2.3.4 AMENDMENT 18: CPL

Relocation of existing artwork

APPROVED PLAN
Drawing: 19402-CPA Ground Floor Plan

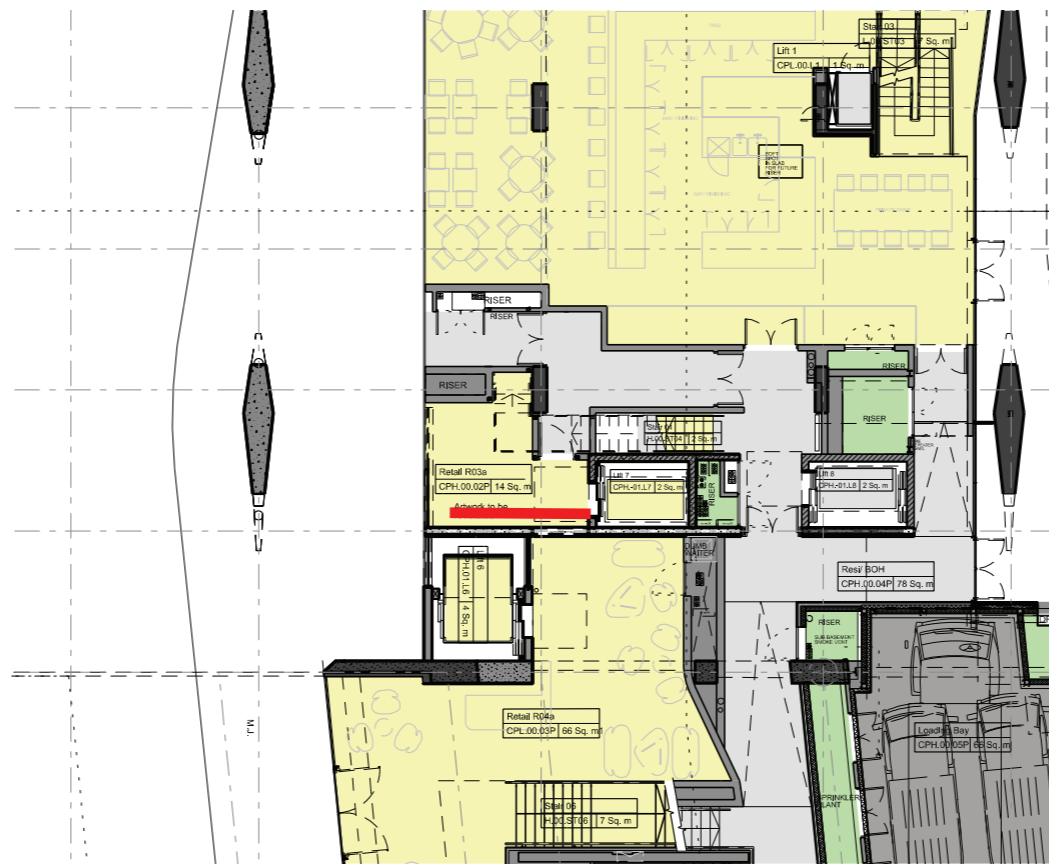
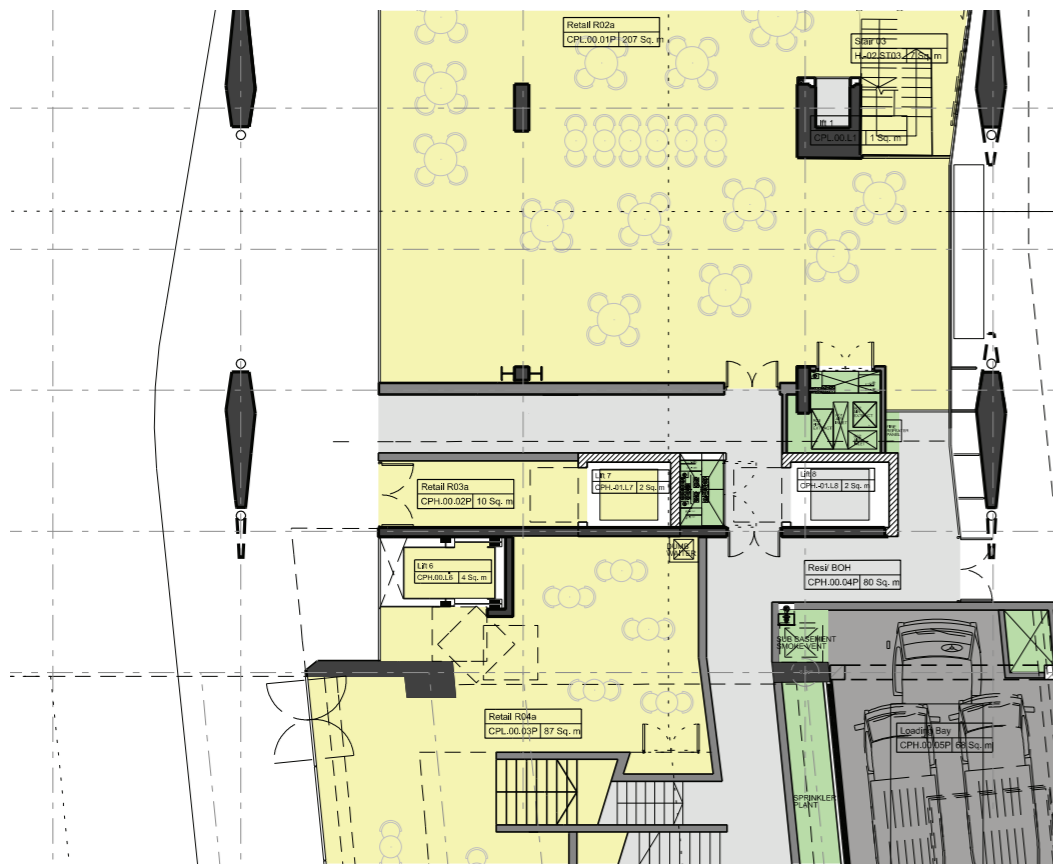
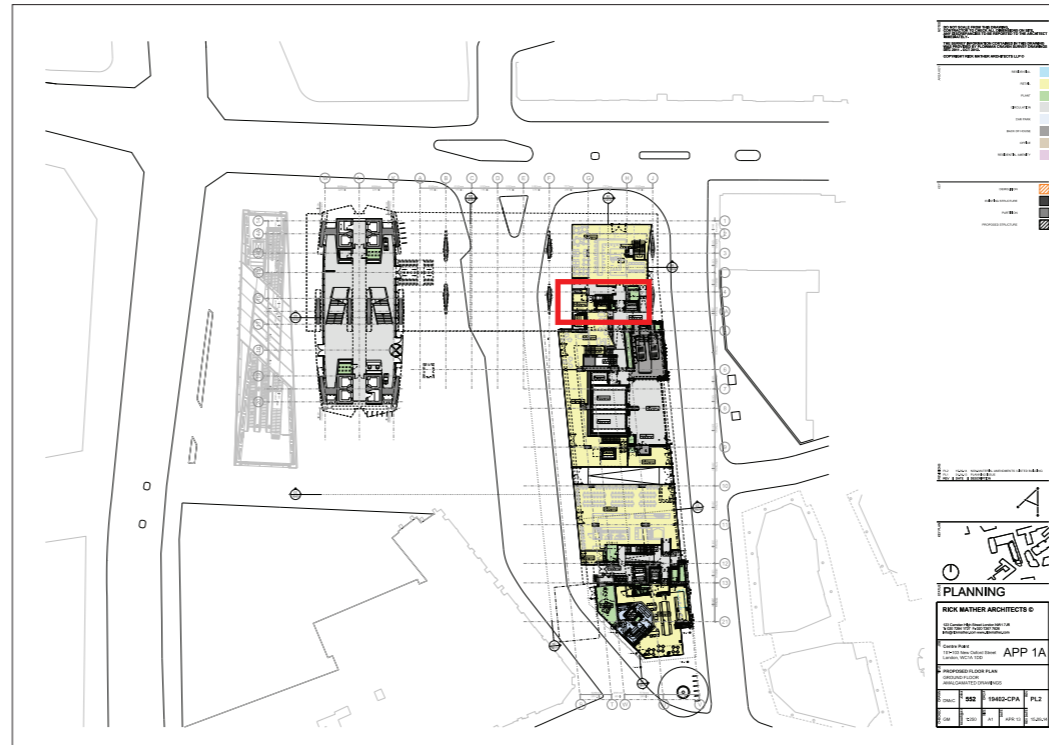
It was originally proposed to refurbish the existing artwork piece and relocate it in the main entrance void adjacent to stair 05 / 06. However, in order to achieve this a significant amount of the existing tiling would need to be replaced as it is likely to be damaged in the process of removing it from the existing background. In addition, it is felt that the existing fixings are unlikely to be recoverable as they are firmly embedded in the existing rc structure.

It is therefore proposed to refurbish the artwork and reinstate it, in its original location, retaining the tiling and fixing locations as they stand.
